FACADE REPAIRS

534 WEST 42ND STREET, NEW YORK, NY 10036

Site Visit - 04.23.2025

Progress Visit Photos

12

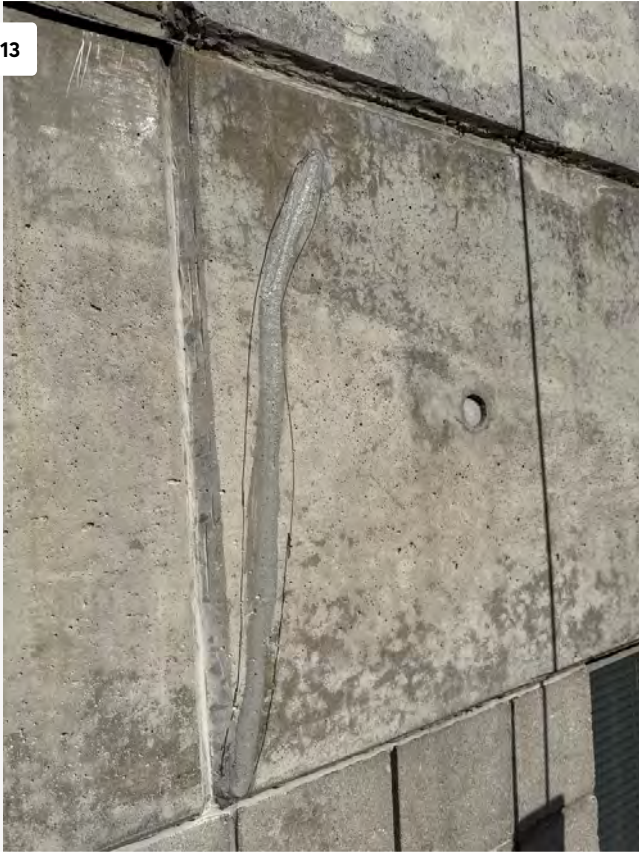
Crack Repair at East Elevation, Crack Still Visible and Will Need to Be Addressed

17

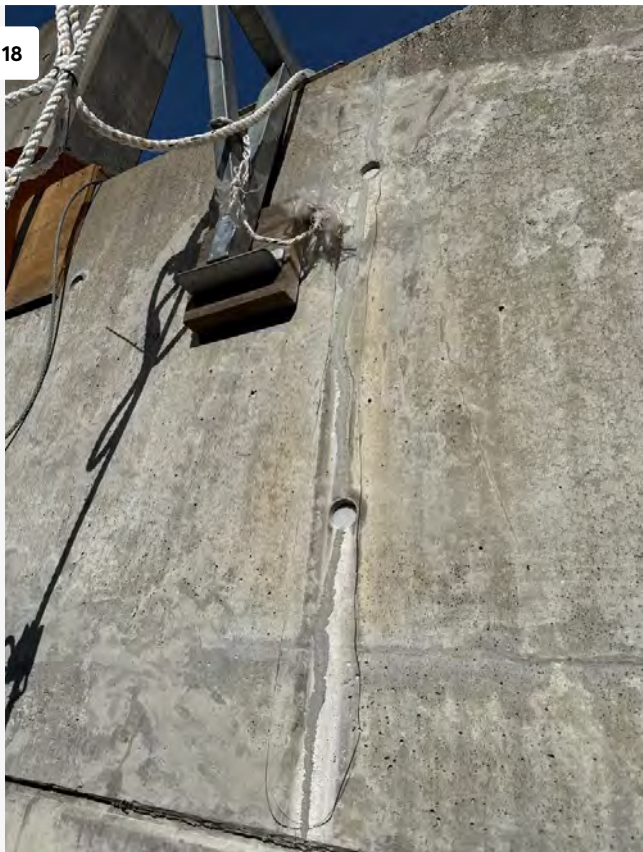
Crack Repaired at East Elevation
